TECH BULLETIN 128

Product changes to crankcase, bearing covers, and shaft protector for all 15 and 18 Frame plunger pumps

New Crankcase Style

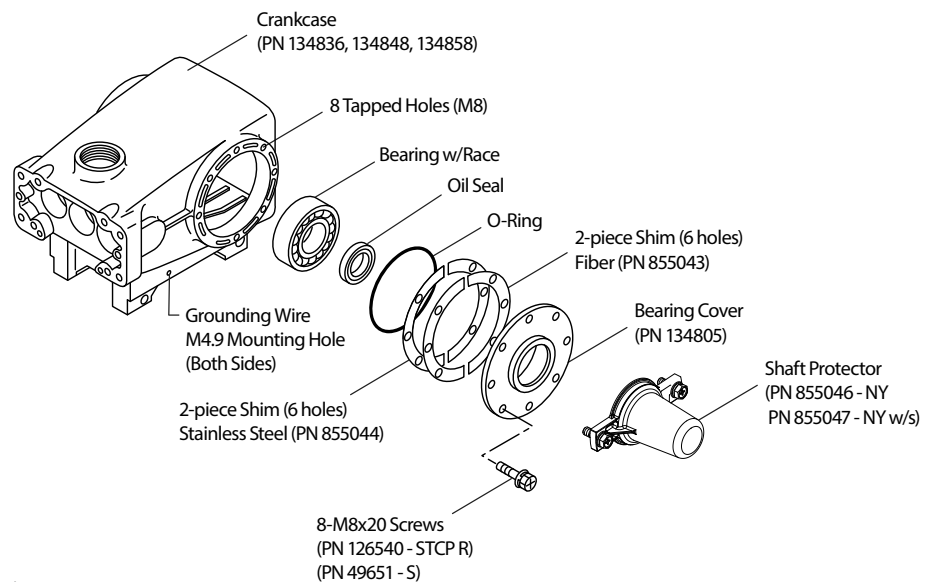
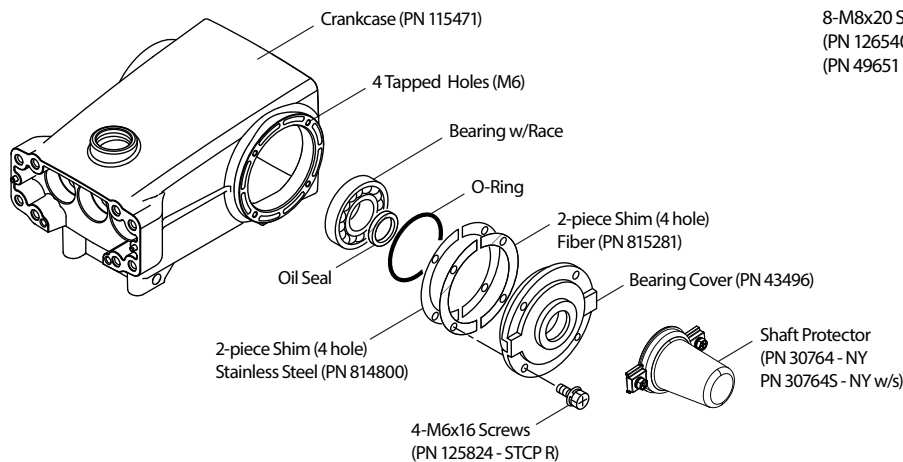
Changes have been made to the crankcase and mounting hardware to better support the weight of direct drive bell housings. This affects all 15 and 18 frame plunger pumps with date codes/serial numbers after April 2019. (See reverse side for specific models)

- Crankcase bell housing mounting bolt holes number increased from four (4) to eight (8) to better distribute weight of motor on crankcase.
- Bell housing mounting bolt quantity and sizes changed from four (4) M6 to eight (8) M8 bolts.
- Un-tapped M4.9 - sized grounding wire mounting holes have been added on both sides of the crankcase.
- M4.9 I.D. hole (both sides) can be tapped to a M6 thread.

- Bearing cover bolt holes enlarged (Four [4] x M9) to accommodate M8 bolt size.
- Shaft protector bolt holes enlarged (Two [2] x M9) to accommodate M8 bolt size.
